REPORT

11th meeting of GRRF Informal Working Group on Automatically Commanded Steering Function

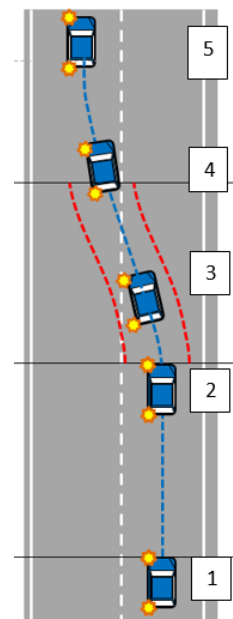
Discussion about the moment to switch off the turn indicator.

(NL): Believes, that the turn indicator lamps should stay on until CAT B1 has stabilized the vehicle in the lane (“5”).

(UK): Personally, he would switch off the turn indicator lamps at point “4”, but he will clarify this UK-internally.

(UK): We have to avoid, that the vehicle moves to the lane edge after “1”, because then the lane change manoeuvre has started already.

Homework: OICA to make a new proposal on the definitions
